Moorebank Intermodal Precinct East – Stage 2 Modification 3

Subdivision of two additional lots, changed frequency for compliance reporting, changed signage requirements and administrative updates to conditions.

State Significant Development Modification Assessment
(SSD 7628 MOD 3)

December 2020

Figure 3 | Proposed modification – Additional proposed lots (shown in red) (Source: Applicant's Modification Report).

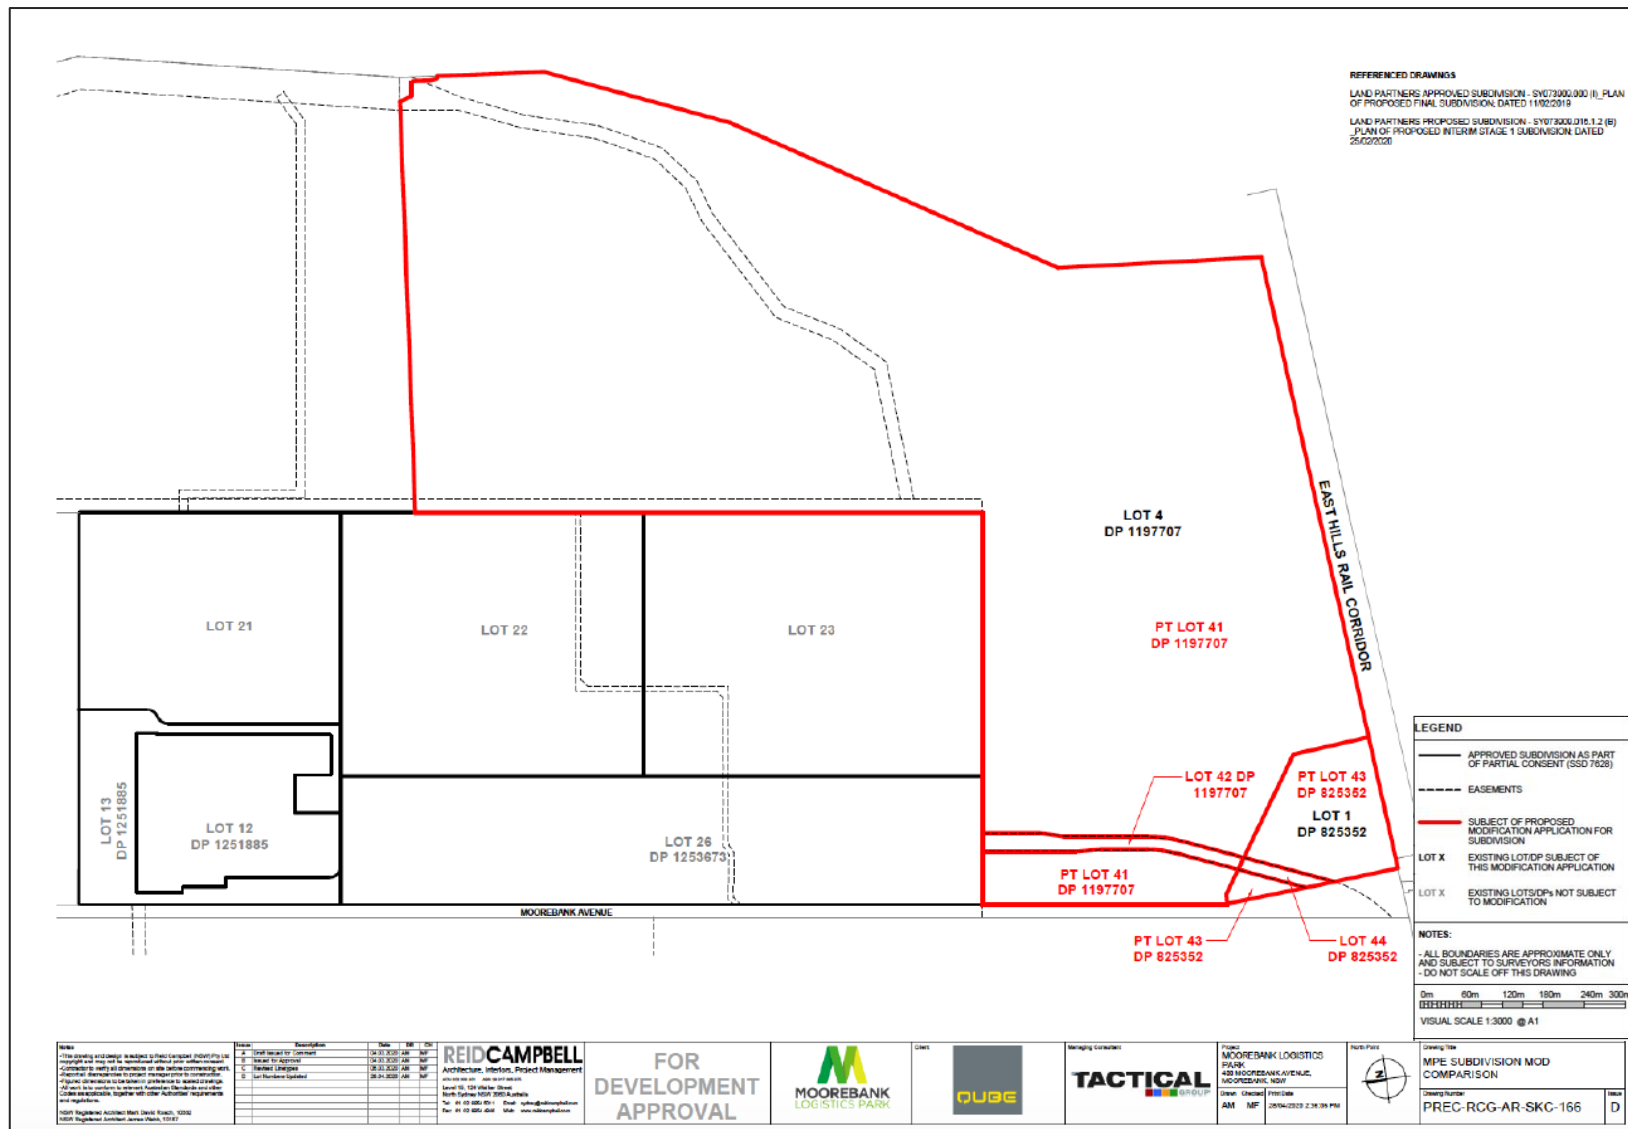
The Applicant submits that proposed lot 42 DP 1197707 (0.90 ha) and proposed lot 41 DP 1197707 (99.09 ha) do not comply with the minimum subdivision lot size requirement of 120 ha for the 'Boot land' area under Liverpool Local Environment Plan (2008) (LLEP). Consequently, the Applicant seeks to vary the minimum subdivision lot size development standard and seek permission for these smaller lots. See **Table 3** below.

The Applicant prepared justification for the departure from the development standard in the form of a clause 4.6 variation request (**Appendix A**). While a clause 4.6 variation request is not required for modifications to development consents, the form of the request provides relevant information for the Department to consider whether the smaller lot sizes are acceptable on planning grounds. Further, the Department notes that proposed lot 42 DP 1197707 is currently approved as easement 'G' on the MPE subdivision plan. The Department's detailed consideration of the proposed subdivision is provided at **Section 6.1**. **Figure 3** provides an overview of the additional proposed lots (shown in red).

The Department is satisfied that the modification request is substantially the same development as originally approved and that the proposed subdivision can be appropriately managed through existing conditions of consent.

Figure 4 | MARW alignment in relation to MPE subdivision boundaries (Source: Applicant's RtS)

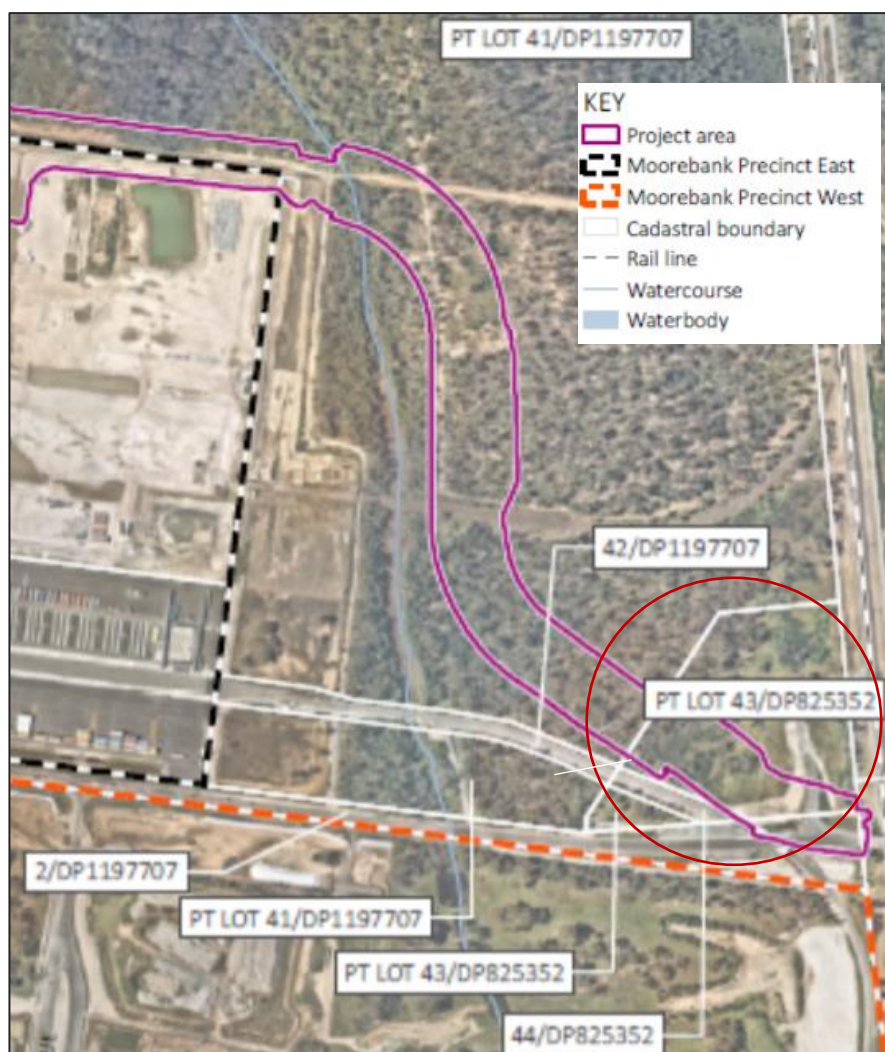
In its submission on the modification application, TfNSW raised concern that subdivision of existing Lot 1 DP 825352 and Lot 4 DP 1197707 may complicate delivery of agreed developer contributions set out in the Voluntary Planning Agreement (VPA) between TfNSW and the Applicant. TfNSW also requested further information on the potential impacts of the proposed modification on the Moorebank Avenue Realignment (MARW) proposal and the Cambridge Avenue Upgrade proposal.

Further, the Applicant advised that the proposed subdivision would have no impact on the proposed MARW as:

- no physical works are proposed
- the proposed MARW alignment enters and exits the Boot Land lot (Lot 4 DP 1197707) without conflicting with the proposed rail access corridor (proposed Lot 42 DP 1197707, currently referred to as easement 'G' on MPE subdivision plan)
- the proposed MARW alignment enters the RailCorp wedge (Lot 1 DP 825352) without conflicting with the proposed rail access corridor (proposed Lot 44 DP 825352) (**Figure 4**). Notwithstanding, the Applicant advised that interaction between the MARW and proposed Lot 44 DP 825352 is subject to future detailed design.

In response, TfNSW recommended that any design for the MARW should enable dedication of all required land as public road, consistent with the VPA, including any encroachment on proposed Lot 44 DP 825352. Council raised no concerns regarding the Applicant's proposed subdivision and clause 4.6 variation request.

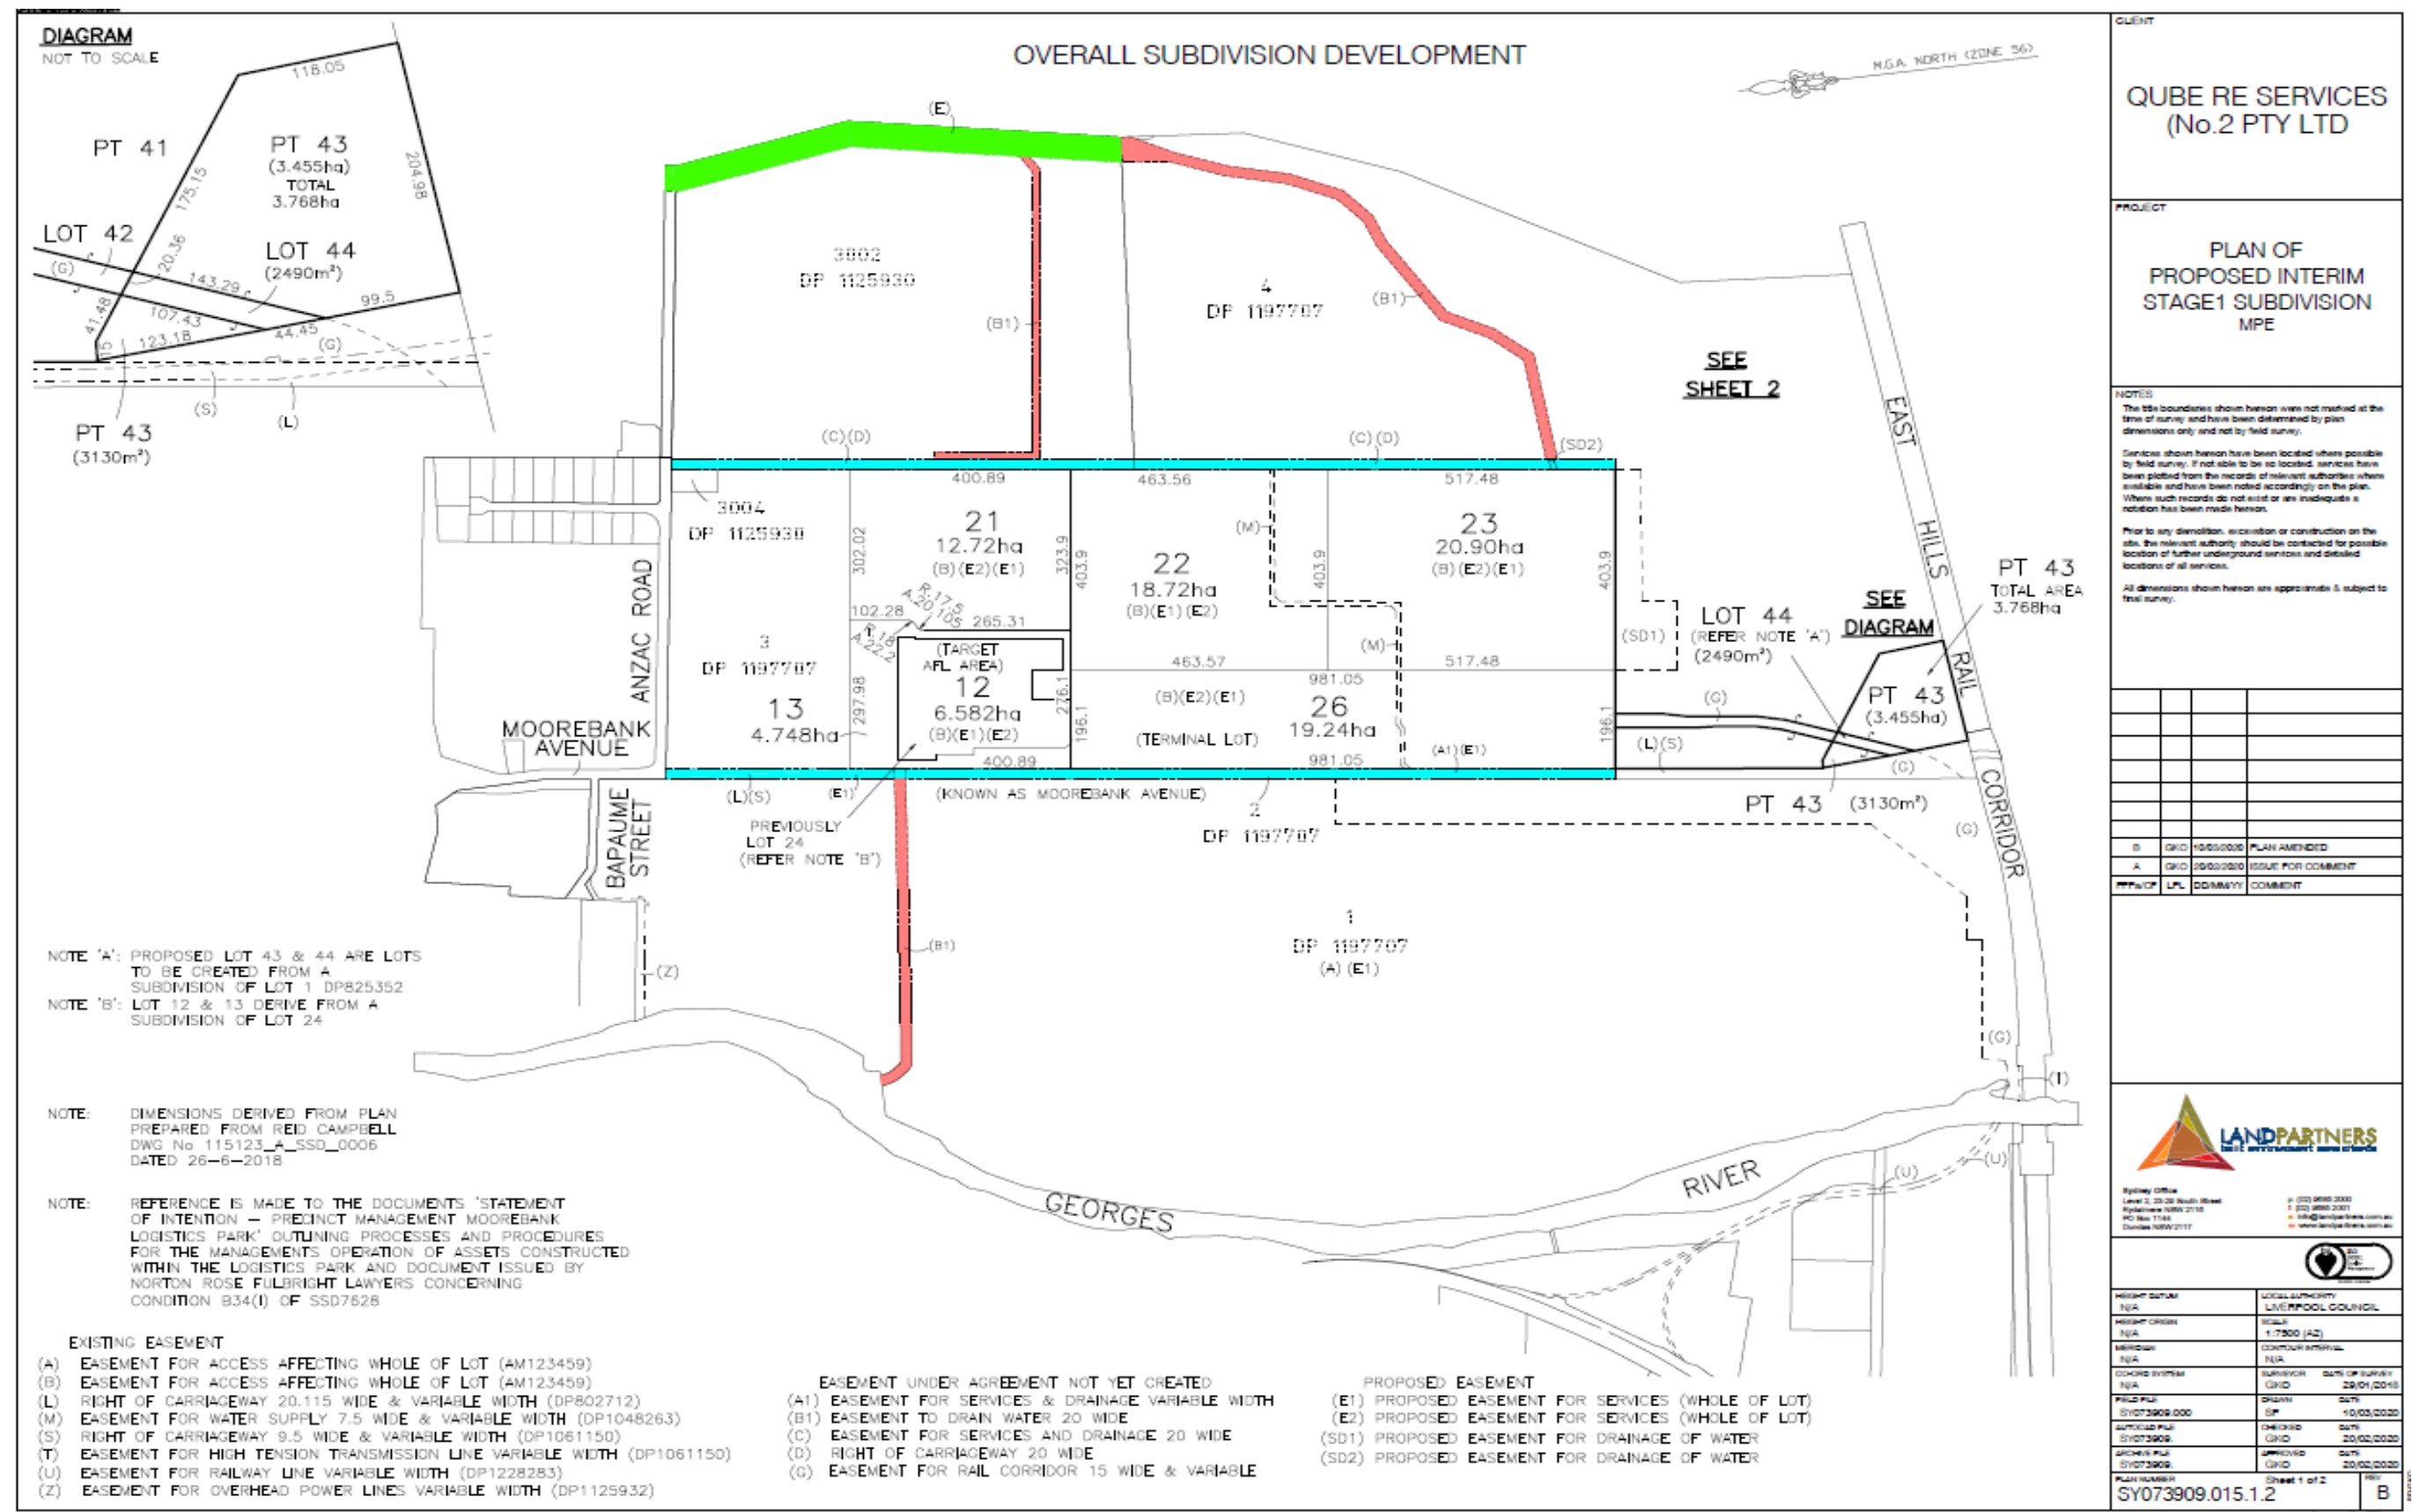
The Department proposes to amend Appendix 1 of the MPE Stage 2 subdivision development consent to include the updated subdivision plan for the site (see **Figure 5**). **Figure 5** provides the proposed overall subdivision plan for the MPE site, including existing easements, easements under agreement not yet created and proposed easements.
